# Access Compliance Report

## Public Rights-of-Way

### (Pedestrian Signals)

Intersection ID: N/A	Main Street:	Cross Street: N/A	Location: N/A
ADA ID: D30EDB5A3EF6	Signal Type: One Push Button-Non APS	Overall Compliance: No	Severity Score: BTN 1: N/A BTN 2: N/A No BTN: N/A
Codes/Mitigation Info/Possible Solution		Field Measurements/Component Compliance

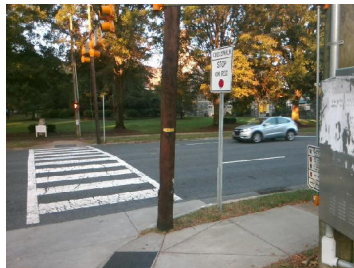
Possible Solutions: Replace Signal Push Button With APS Button on New Post. Remove & Relocate Sign.
